QUAD CITIES NUCLEAR POWER STATION UNIT 1

AMENDMENT TO FACILITY OPERATING LICENSE

Amendment No. 61
License No. DPR-29

ATTACHMENT TO LICENSE AMENDMENT NO. 61

FIGURE 3.5-1
(Sheet 1 of 6)

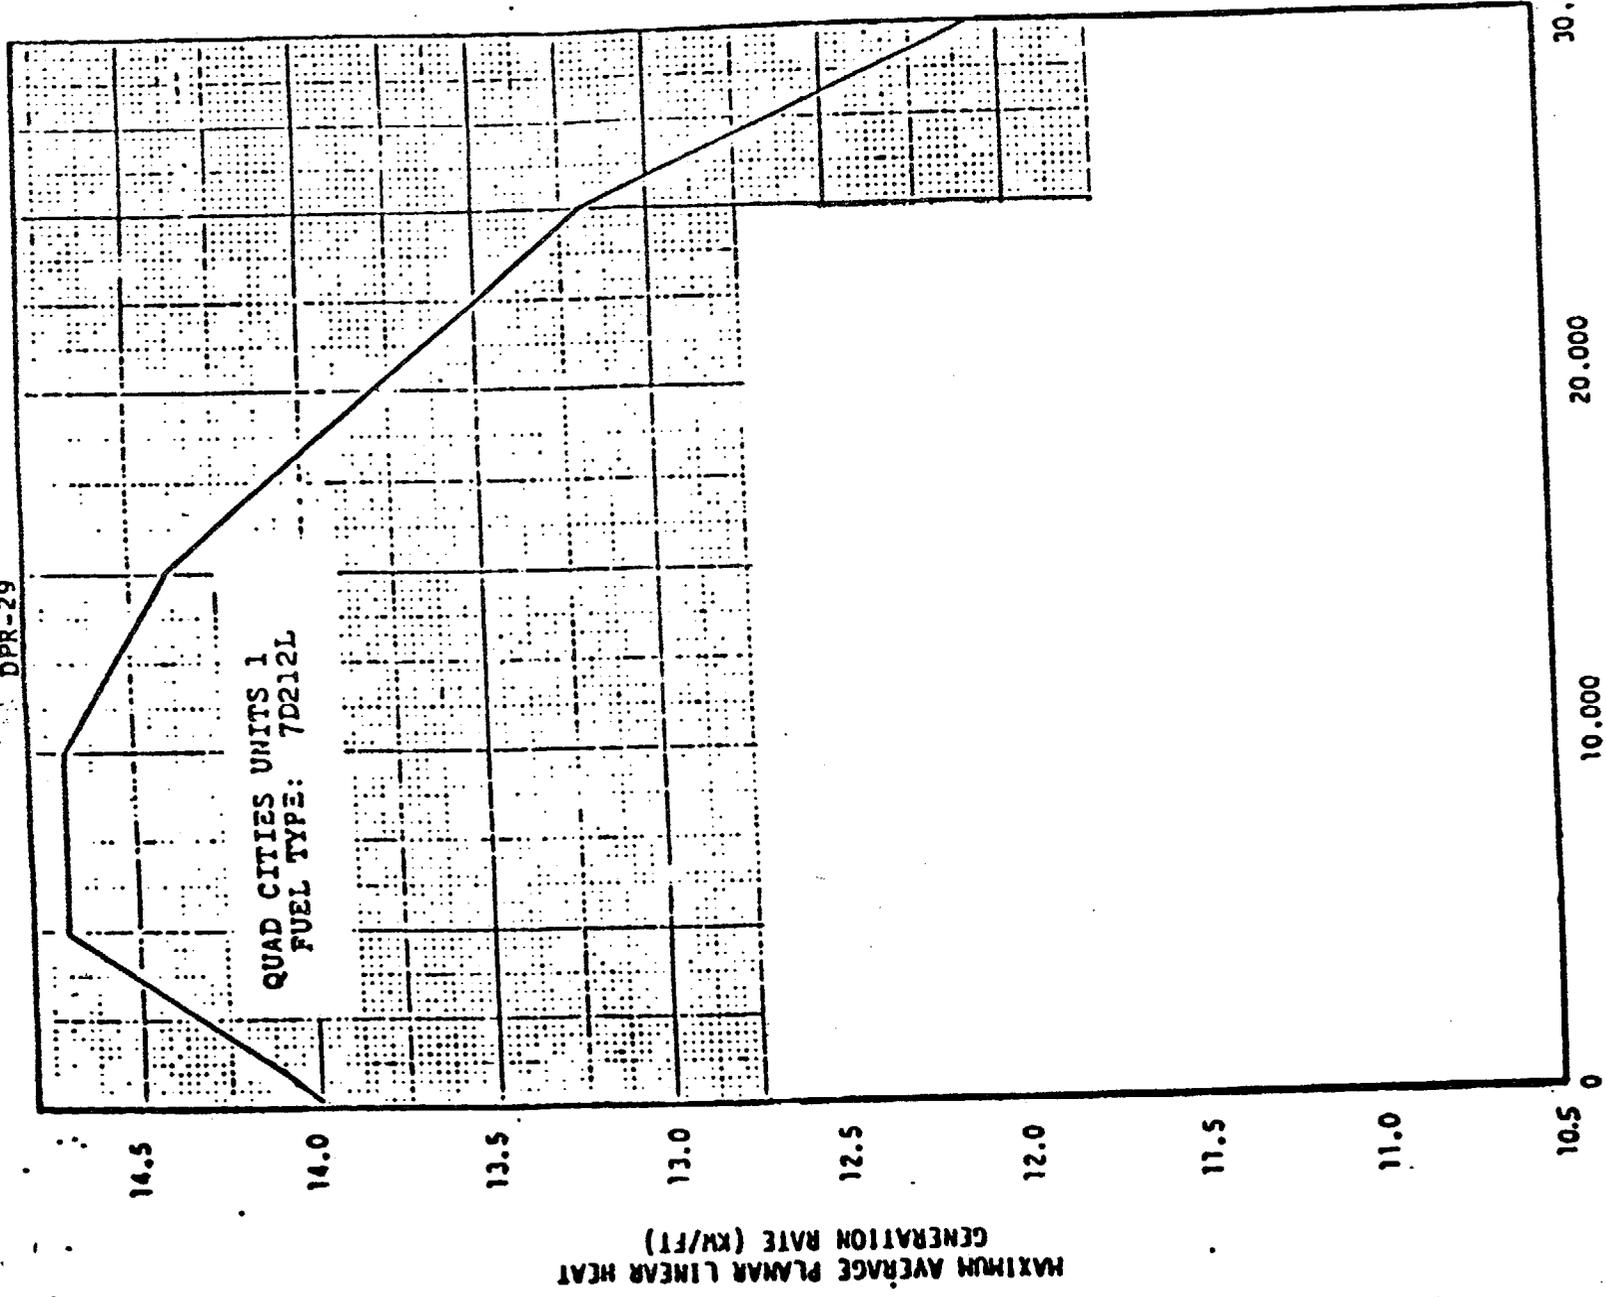
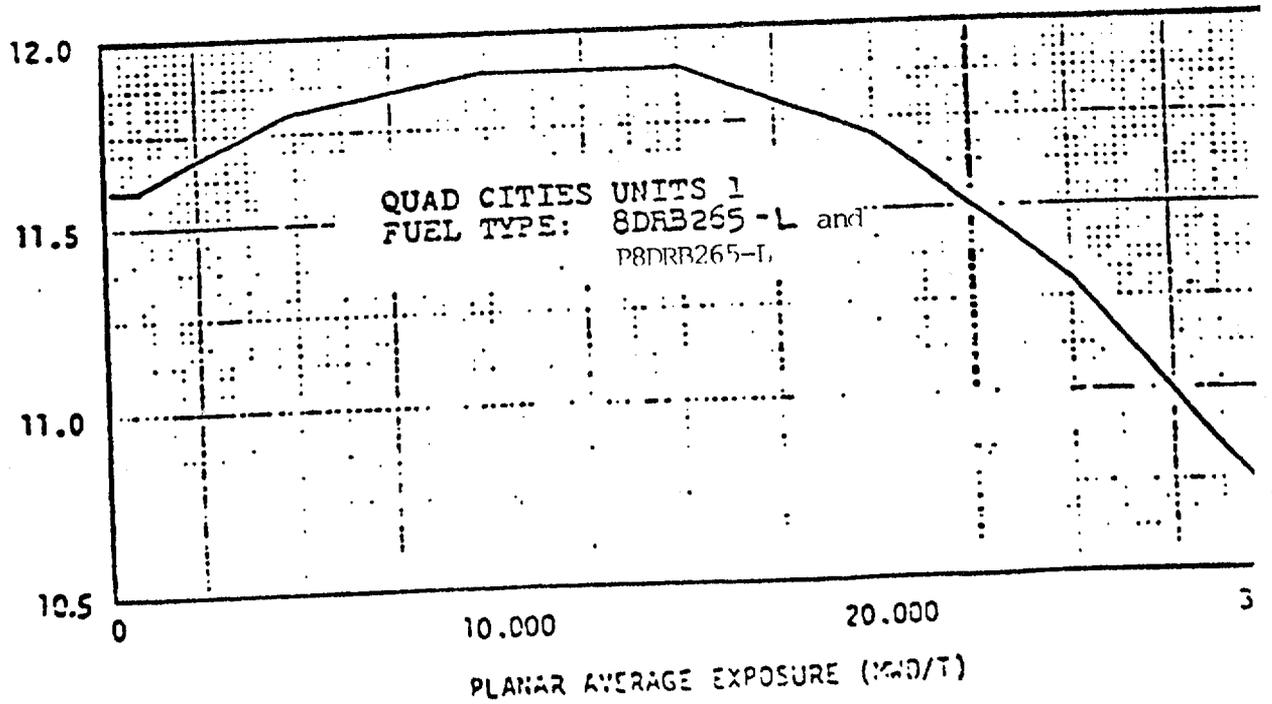
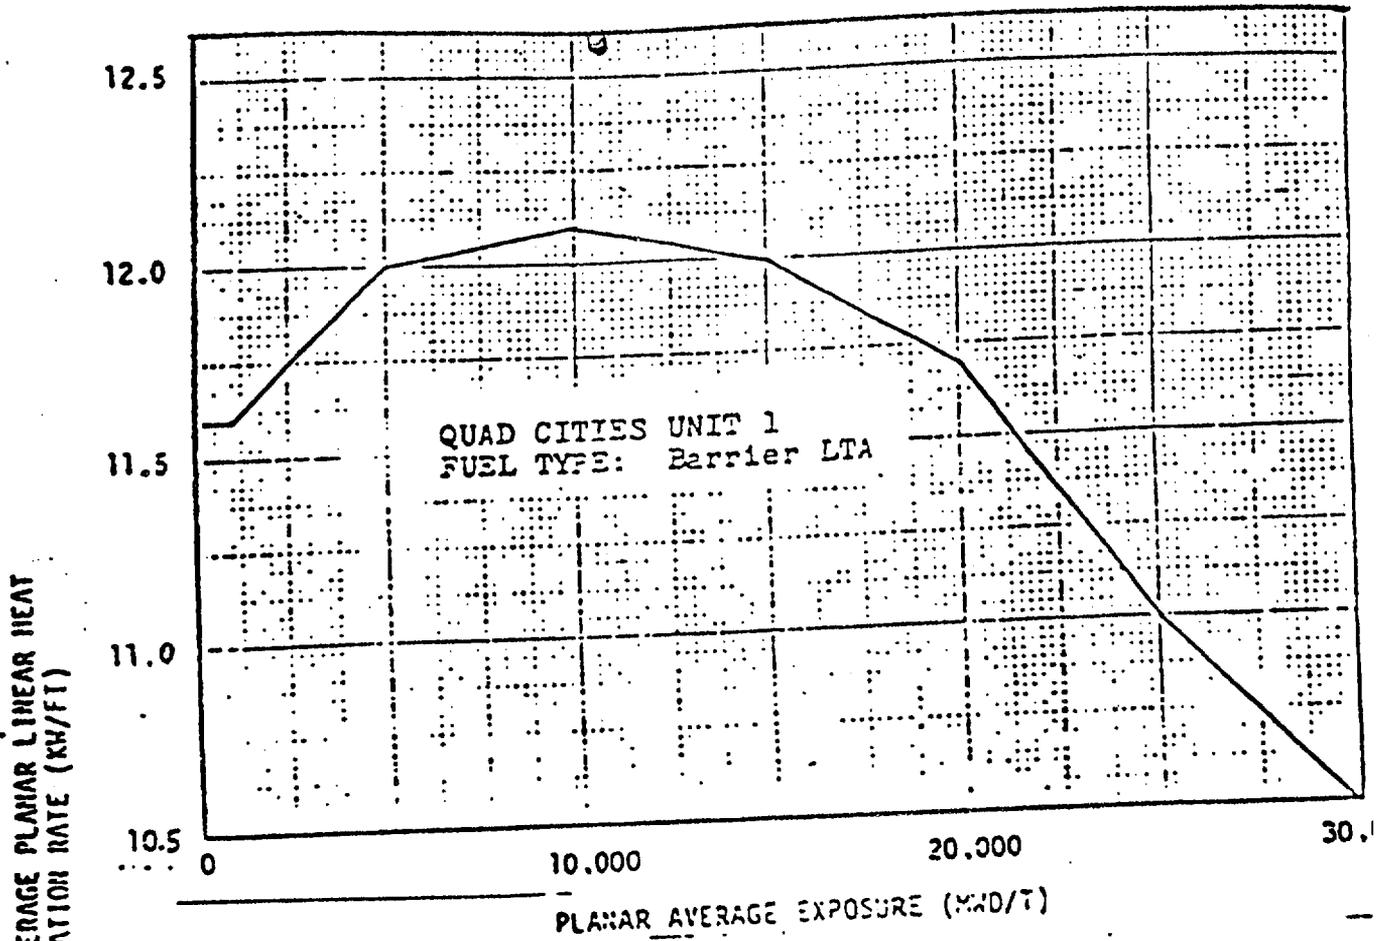
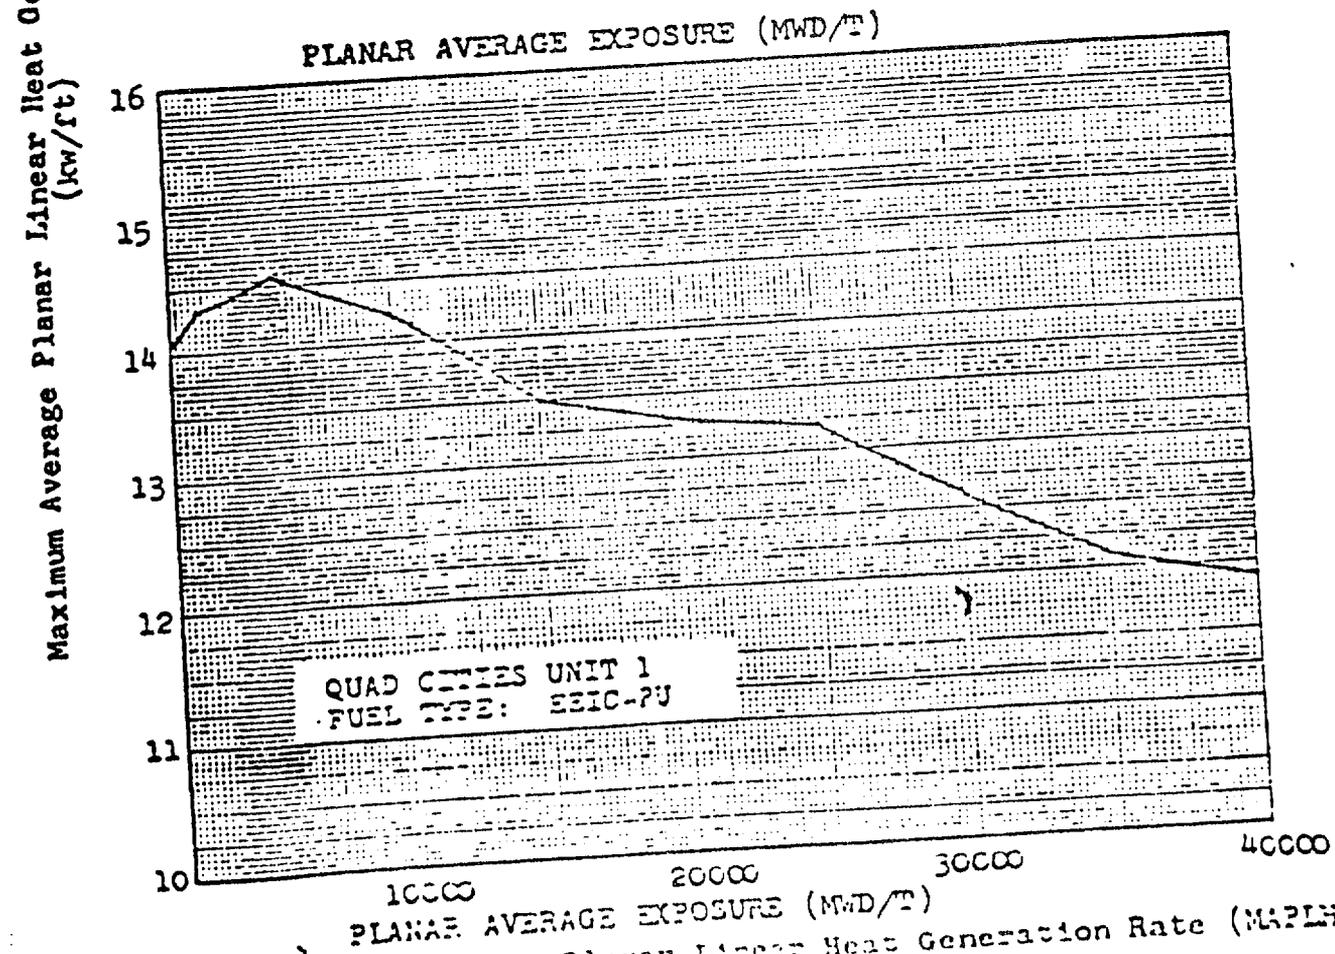
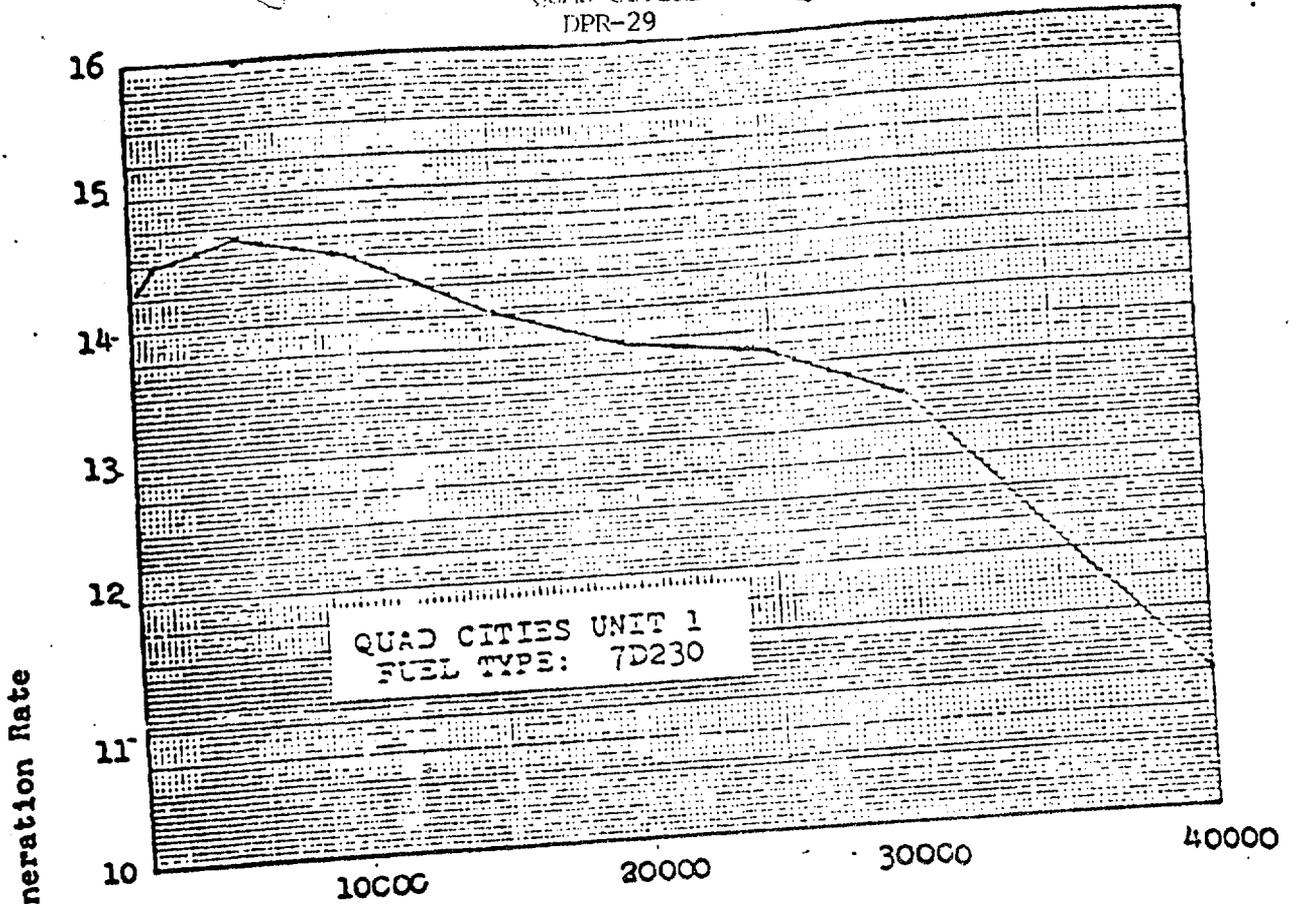
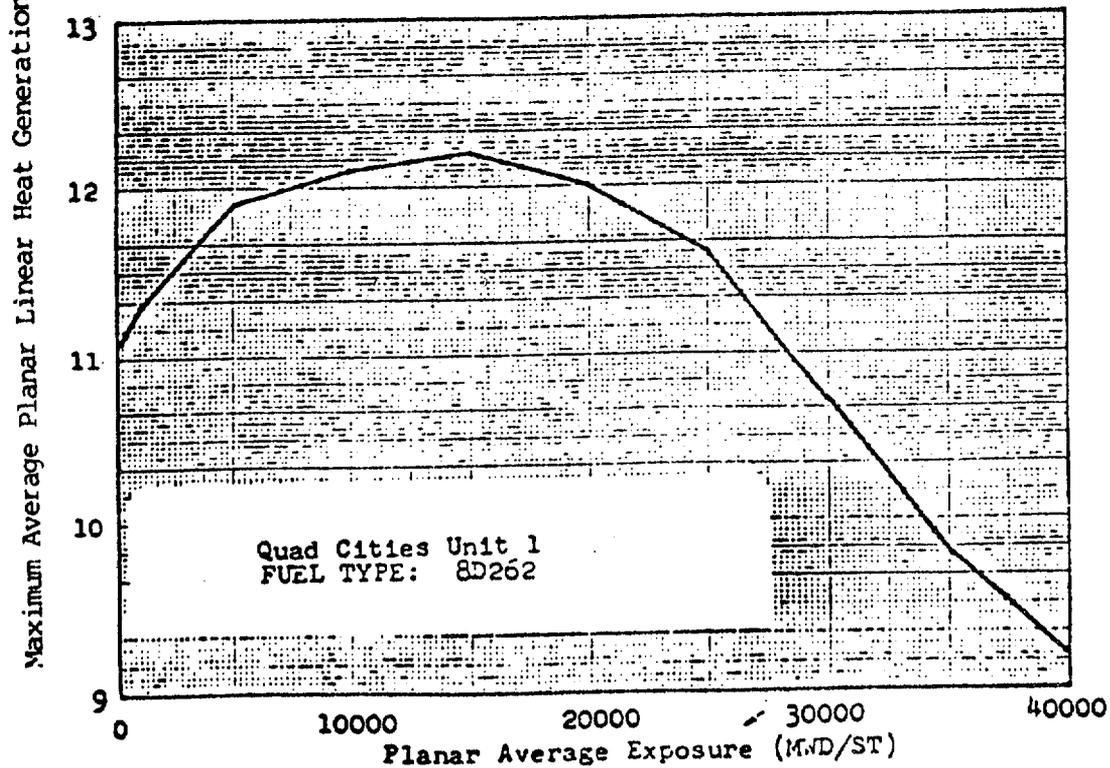
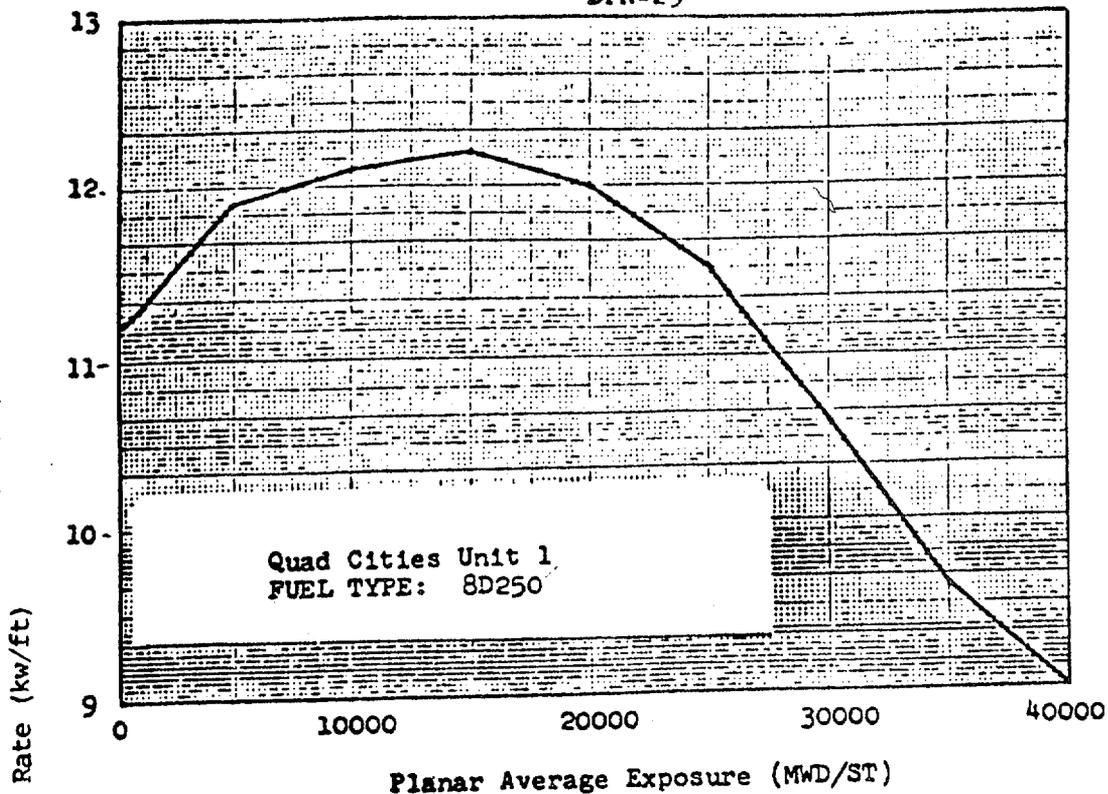
2. Page 1.1/2.1-2a is added.
3. Figure 2.1-2 is deleted.
4. Figure 3.5-1 is being replaced by 6 pages.

During steady-state power operation, the average linear heat generation rate (APLHGR) of all the rods in any fuel assembly, as a function of average planar exposure, at any axial location, shall not exceed the maximum average planar LHGR shown in Figure 3.5-1.

The peak cladding temperature following a postulated loss-of-coolant accident is primarily a function of the average heat-generation rate of all the rods of a fuel assembly at any axial location and is only secondarily dependent on the rod-to-rod power distribution within an assembly. Since expected local variations in power distribution within a fuel assembly affect the calculated peak cladding temperature by less than $\pm 20^\circ\text{F}$ relative to the peak temperature for a typical fuel design, the limit on the average planar LHGR is sufficient to assure that calculated temperatures are below the limit. The maximum average planar LHGR's shown in Figure 3.5-1 are based on calculations employing the models described in Reference 2.

Maximum Average Planar Linear Heat Generation Rate (MAPLHGR)
